Lakeview Retail along Broken Land Parkway
 Design Advisory Panel
 2018-07-25 Review (18-12)

Ref #	Design Advisory Panel Recommendation	Response by Applicant 2018-08-06	DPZ Director's Endorsement
1.	<p>The applicant enhance pedestrian connections across the site from east to west with paved crossings and islands.</p> <p>Vote: 4-0 (approved)</p>	<p>For purposes of the Phase I development, Applicant shall provide pedestrian connections from the 9801 & 9821 BLP buildings to the proposed building as shown during the DAP presentation. If/when the Phase II building is developed, Applicant shall enhance pedestrian access across the site from east to west.</p>	<p><input checked="" type="checkbox"/> Accept DAP Recommendation <input checked="" type="checkbox"/> Accept Applicant Response</p>

PERSPECTIVE VIEW FROM BROKEN LAND PARKWAY

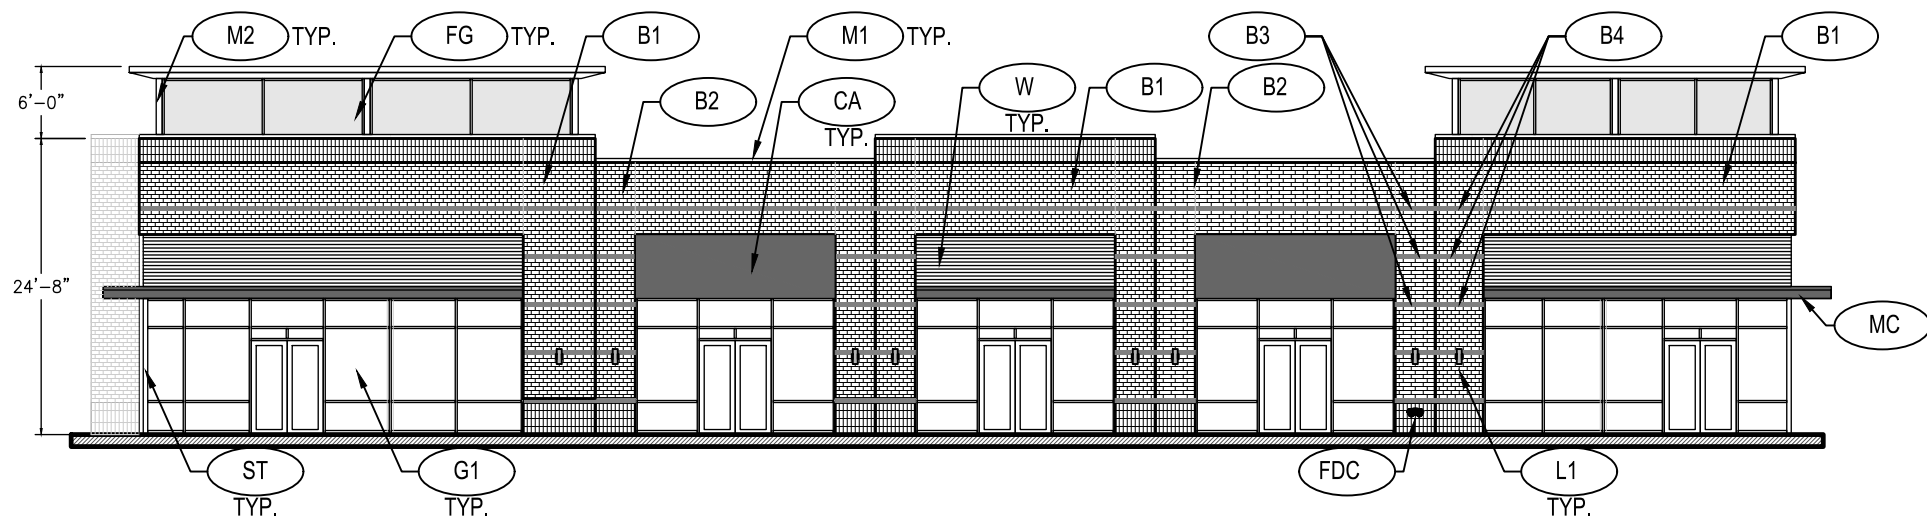
5.	<p>The applicant redesign the architecture to be more contemporary and better match adjacent office buildings.</p> <p>Vote: 4-0 (approved)</p>	<p>Albeit different colors than the 9801 – 9861 BLP buildings, the adjacent Woodmere Office Center and (close proximate) Patuxent Woods office center are also masonry. Applicant believes that the architecture as proposed is in concert with the 9801 – 9861 buildings, which are more traditional in design. However, Applicant</p>	<p><input checked="" type="checkbox"/> Accept DAP Recommendation <input checked="" type="checkbox"/> Accept Applicant Response</p>

will revisit this detail with the design team to incorporate a more contemporary design.	
--	--	--	--
